**TO:** Mayor Edward Johnson, City of Fayetteville  
**ATTN TO:** David Rast, Community Development Director, City of Fayetteville  
**FROM:** Mike Alexander, COO, Atlanta Regional Commission  
**RE:** Development of Regional Impact (DRI) Review

**Name of Proposal:** Fayetteville City Center DRI 4306

**Description:** A DRI review of a proposal to construct a mixed-use project with 34,000 SF of retail, a 12,000 SF food market, 120-room hotel, 14,000 SF loft/office, 700 multi-family units, 48 townhome units and 39 single-family lots on a 38.5-acre tract adjoining the City Hall – City Center Park complex in downtown Fayetteville in Fayette County.

C2.00

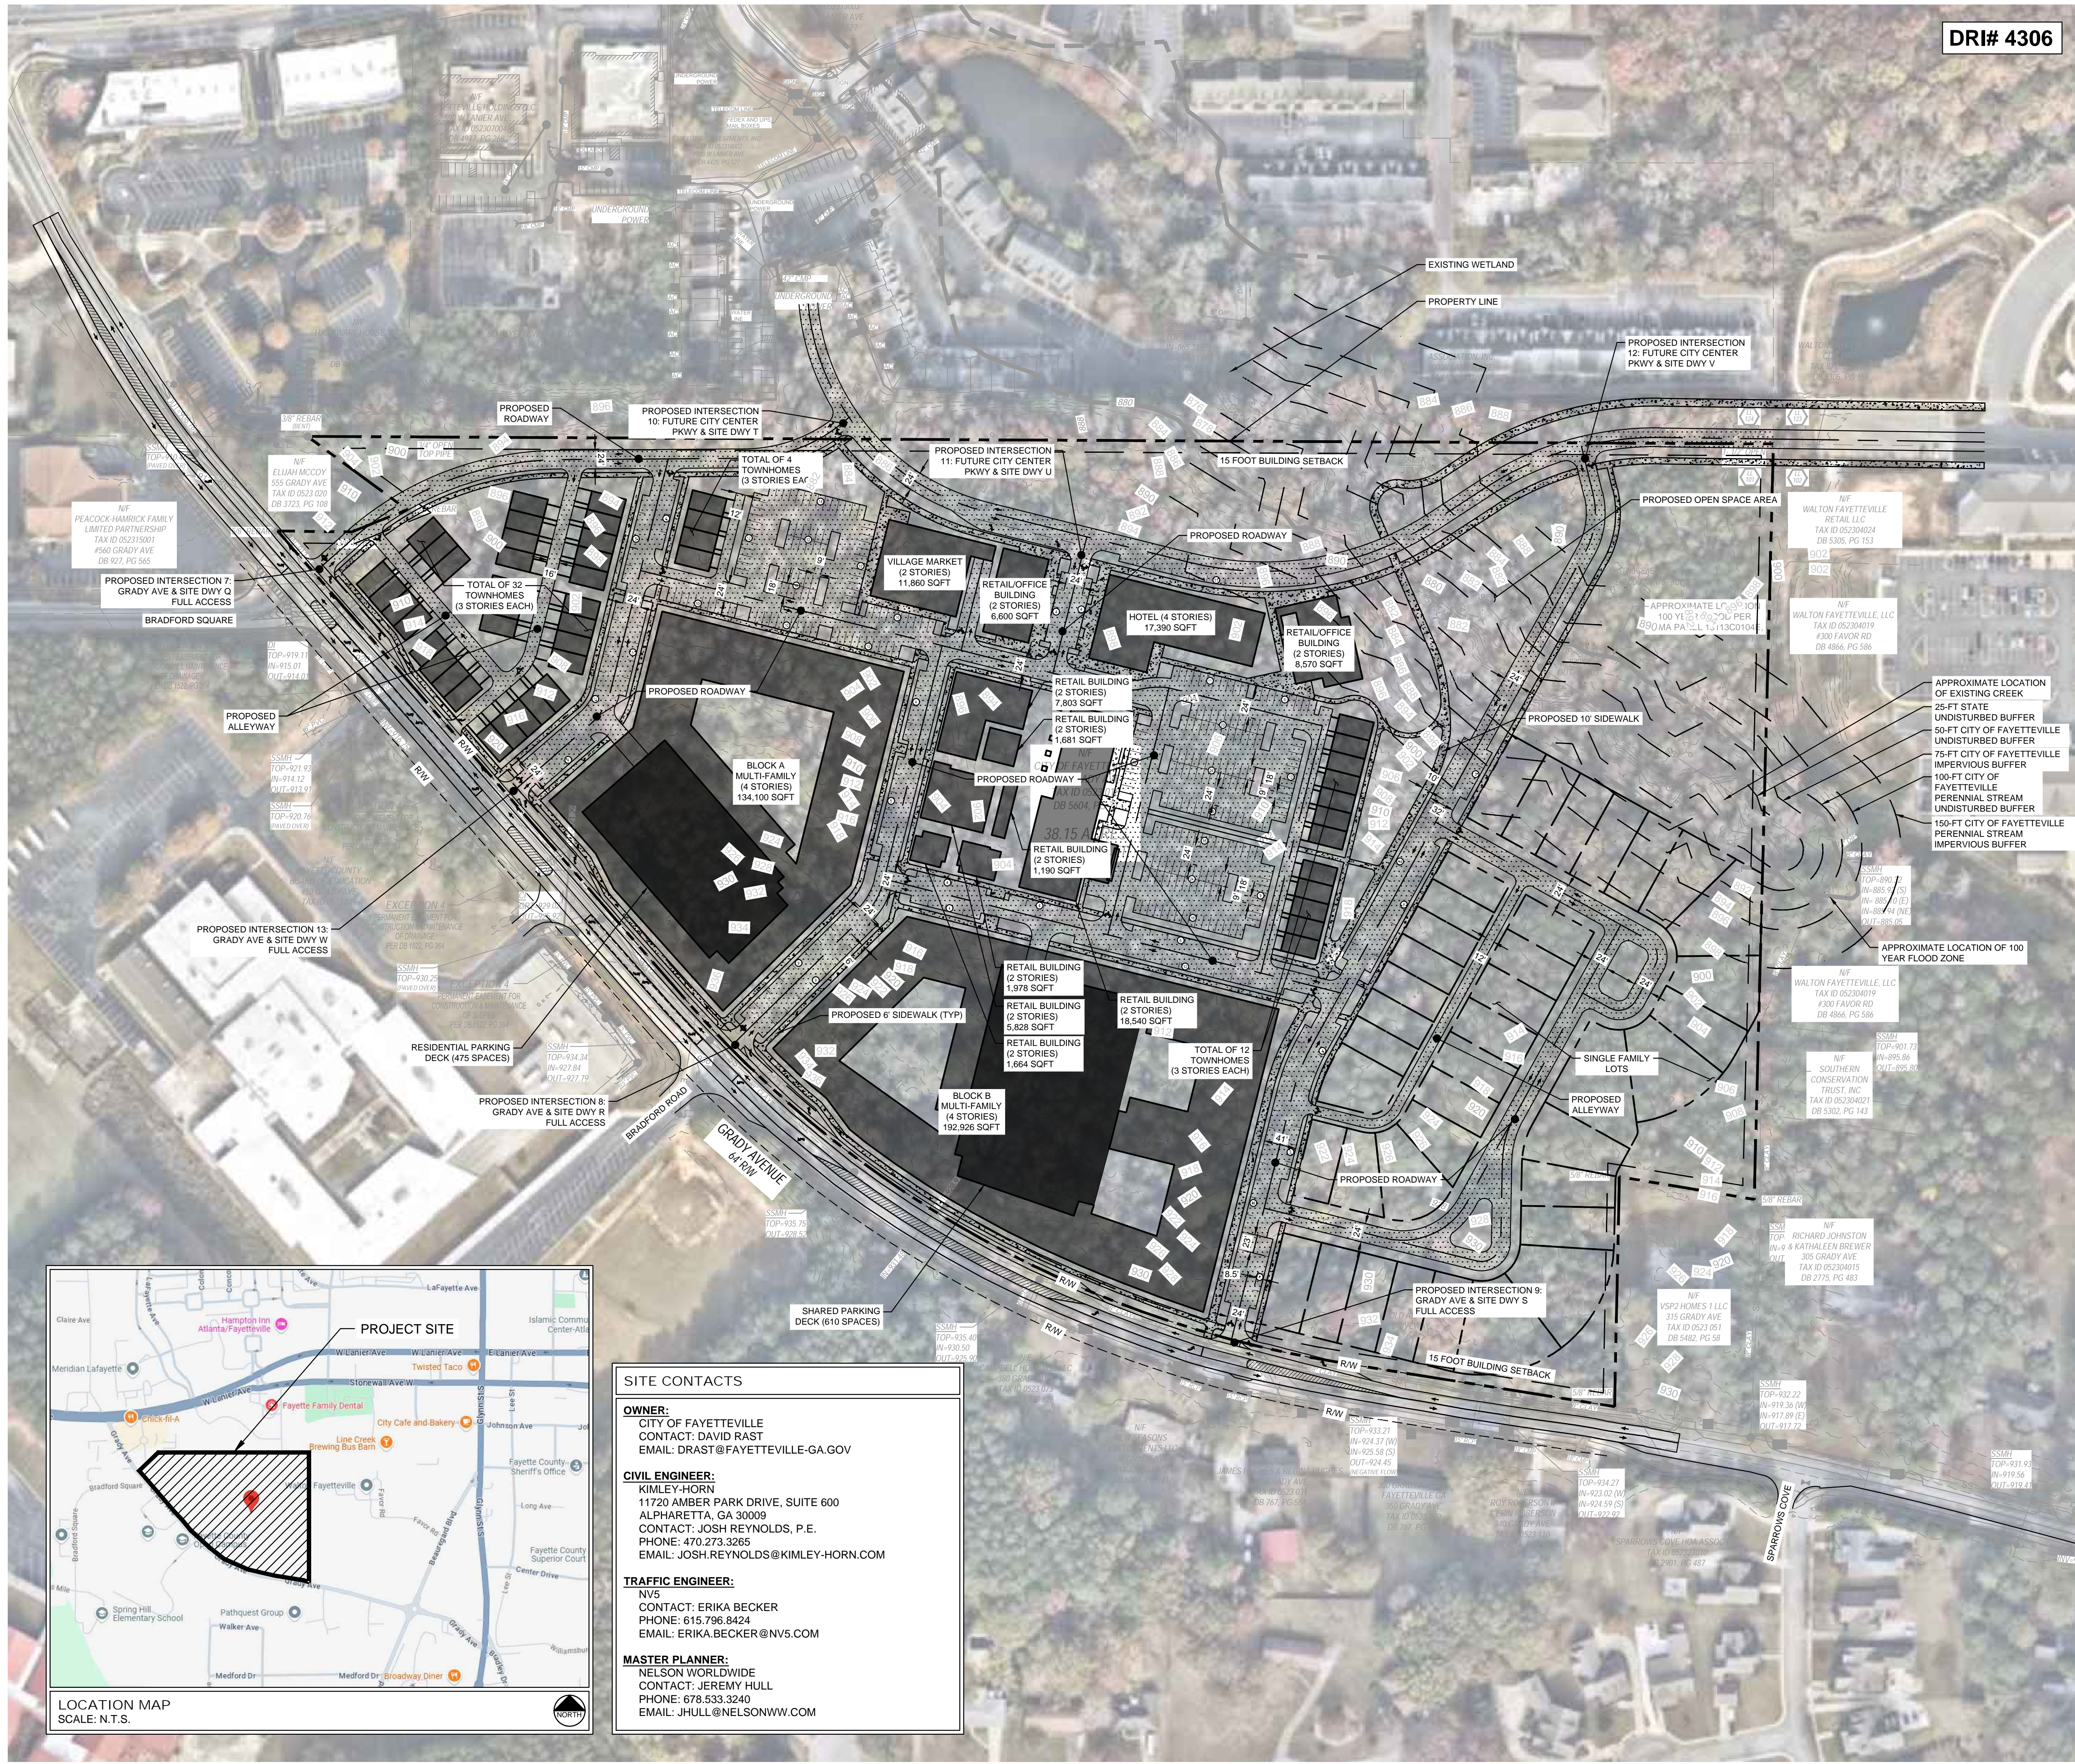
*Some segments of the proposed road network that cross the stream appear to be redundant. Additional valuable natural open space could be created by consolidating these elements.*

*The submitted site plan shows and identifies the 25-foot State Erosion and Sedimentation buffer and the City's 50-foot undisturbed stream buffer and 75-foot impervious setback. The City's 100-foot vegetative buffer and 150-foot impervious wak on all perennial streams in the water supply watershed district are also shown. If the larger buffers are governing, the smaller stream buffers do not need to be shown.*

*Seven of the proposed single-family home lots are located almost entirely within the protected stream buffers along with a two-story retail and office building. Both may require variances from the City. Stream buffers provide a minimal level of water quality protection and are recommended to be preserved to the greatest extent possible.*

Some segments of the proposed road network that cross the stream appear to be redundant. Additional valuable natural open space could be created by consolidating these elements.

If the City 50-foot buffer and 75-foot buffer are the correct buffers, the only clear intrusions into the buffers are two road crossings and sidewalk crossings, which are allowed under the city stream buffer ordinance. However, one retail commercial building is shown nearly at the edge of the 75-foot impervious setback and that setback also extends into seven single-family lots. Any intrusions into the setback, including grading as well as impervious surfaces, may require variances. If the watershed buffer and setback are required, both the proposed retail building and the seven single-family lots will be entirely within the 150-foot setback and will require variances or need to be relocated.

No stormwater management system is shown on the project site plan. The application form lists the following protection measures: "Existing stream buffers to be protected, bioretention areas, bioswales, permeable pavers, underground detention ponds with infiltration". The final project design should adequately address the impacts of the proposed development on stormwater runoff and downstream water quality.

- The site plan doesn't show the connection to LaFayette Ave. When is that connection proposed to be made? If it is not part of the initial roadway network installation, the traffic volume will need rerouting through SR 54 @ Grady and be accounted for in the study.
